**CITY COUNCIL AGENDA ITEM**

**AGENDA ITEM:** **201402368** - 4967 & 4969 Roswell Road, *Applicant: Dewberry Capital*, to rezone the subject property from C-1 (Community Business District) conditional to MIX (Mixed Use District) for the construction of a mixed commercial and multifamily dwelling unit development, with a use permit to exceed the maximum district height and concurrent variances

To: John McDonough, City Manager  
From: Angela Parker, Director of Community Development   
Date: October 6, 2014 for submission onto the October 16, 2014 Planning Commission meeting  
Agenda Item: 201402368 4967 and 4969 Roswell Road

**DEPARTMENT OF COMMUNITY DEVELOPMENT RECOMMENDATION**

ZP-1

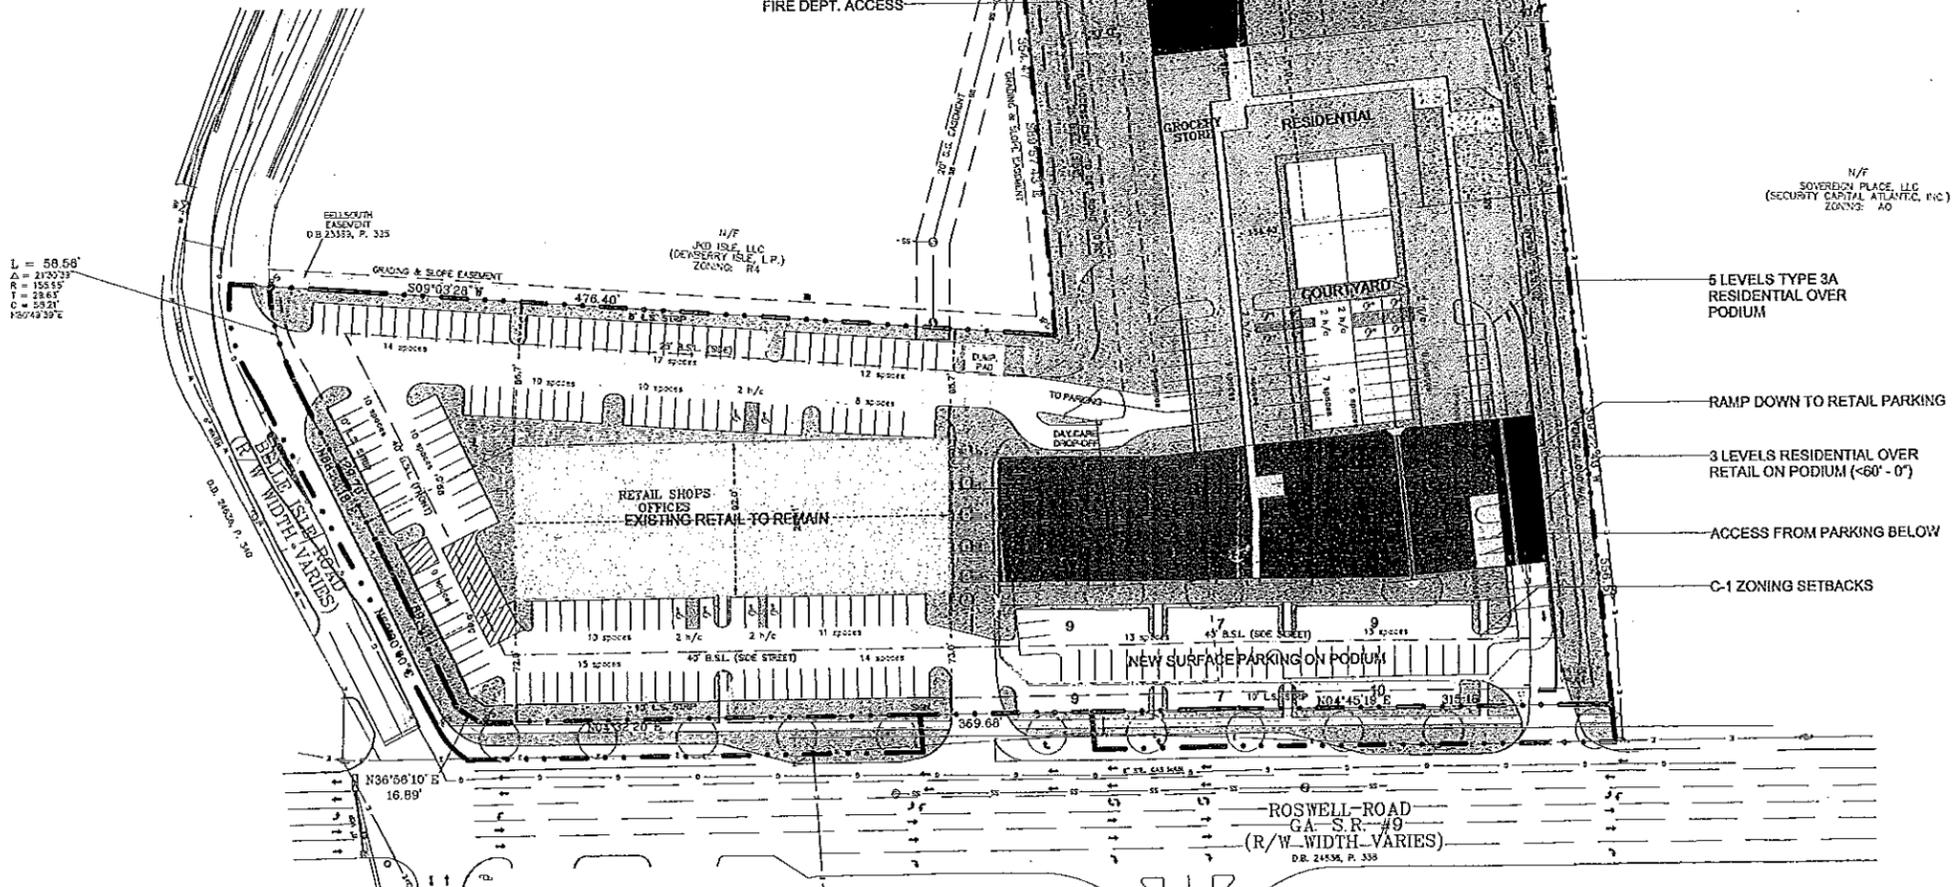
1. Variance from Section 4.23.1 to allow the existing parking to remain in the twenty-five (25) foot buffer and the ten (10) foot improvement setback.

*Staff is of the opinion that the request to allow the existing parking to remain in the twenty-five (25) foot buffer would not be in harmony with the intent of the Zoning Ordinance. The applicant should bring the site into compliance with current regulation upon the redevelopment of the site. Additionally, if the application is denied the legal non-conforming conditions may remain. Therefore, based on these reasons, the staff recommends DENIAL of this variance request.*

2. Variance from Section 4.23.1 to reduce the fifty (50) foot buffer and ten (10) foot improvement setback along the south property line to a ten (10) foot landscape strip.

*Staff is of the opinion that the request to reduce the fifty (50) foot buffer and ten (10) foot improvement setback along the south property line to a ten (10) foot landscape strip is not in harmony with intent of the Zoning Ordinance. The site does exhibit exceptional conditions pertaining to that property because of topography. However, the topography does not constitute a hardship as it pertains to this variance request. Therefore, based on these reasons, the staff recommends DENIAL of this variance request.*

*Staff is of the opinion that the request to reduce the required parking from 5 spaces per 1000 to 4 spaces per 1000 is not in harmony with the intent on the Zoning Ordinance. The site does display some topographical challenges, but none which would support the parking reduction. Therefore, based on these reasons, the staff recommends DENIAL of this variance request.*

The applicant is requesting a use permits to exceed the district height of sixty (60) feet or four (4) stories to sixty-nine (69) feet, six (6) inches

- a. To the site plan received by the Department of Community Development dated November 6, 2014. Said site plan is conceptual only and must meet or exceed the requirements of the Zoning Ordinance and these conditions prior to the approval of a Land Disturbance Permit. The applicant shall be required to complete the concept review procedure prior to application for a Land Disturbance Permit. Unless otherwise noted herein, compliance with all conditions shall be in place prior to the issuance of a Certificate of Occupancy.
